**Economic and Social Council**Distr.: General
7 August 2017

Economic Commission for Europe**Inland Transport Committee****World Forum for Harmonization of Vehicle Regulations****Working Party on Lighting and Light-Signalling****Seventy-eighth session**

Regulations Nos. 37 (Filament lamps), 99 (Gas discharge light sources), 128 (Light emitting diodes light sources) and the Consolidated Resolution on the common specification of light source categories**Proposal for amendment 1 to the original version of the Consolidated Resolution on the common specification of light source categories****Submitted by the expert from the International Automotive Lighting and Light-Signalling Expert Group (GTB)***

Sheet H9/1, figure 1, amend to read:

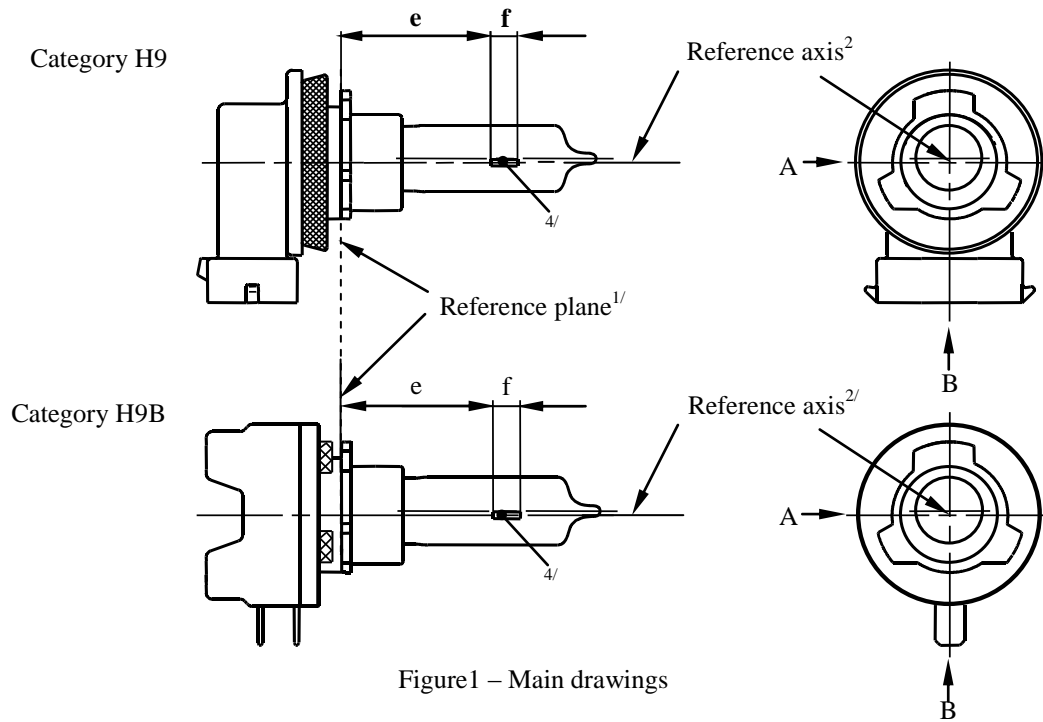
Replace by the correct drawing, to read:
